MIL-C-45954(WC)
AMENDMENT 2
11 June 1976
SUPERSEDING
AMENDMENT 1
18 December 1975

CONTROLLER, WEAPONS GUN SPEED

AND LAUNCHER BRAKE, RH

This amendment forms a part of Military Specification MIL-C-45954(WC), dated 23 July 1974.

FIGURE 1

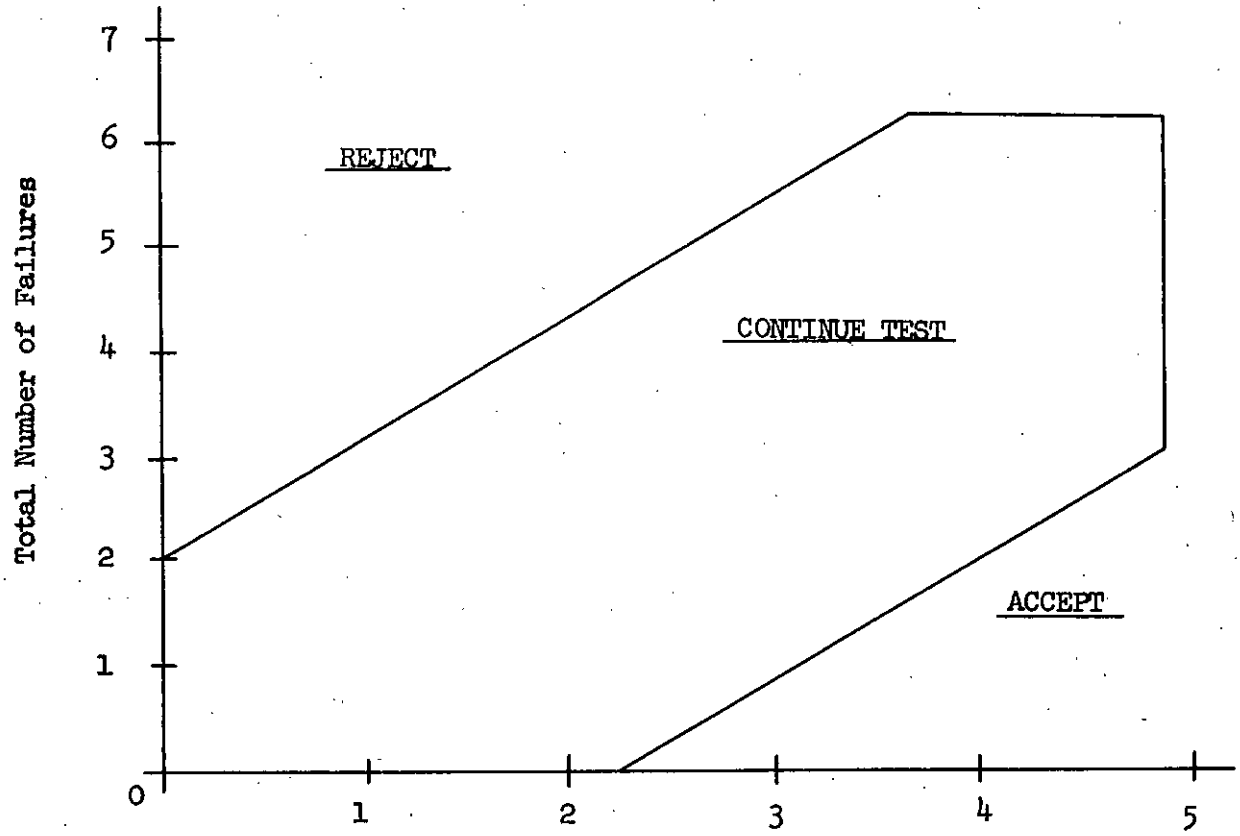
Add the following "Figure 1" as the last page to the specification.

Decision Risks: 30%
Discrimination Ratio: 1.5:1
MIL-STD-781 Test Plan VII

NO. OF FAILURES	REJECT (EQUAL OR LESS)	ACCEPT (EQUAL OR MORE)
0	N/A	2248
1	N/A	3115
2	N/A	3983
3	867	4850
4	1734	4850
5	2601	4850
6	4850	N/A
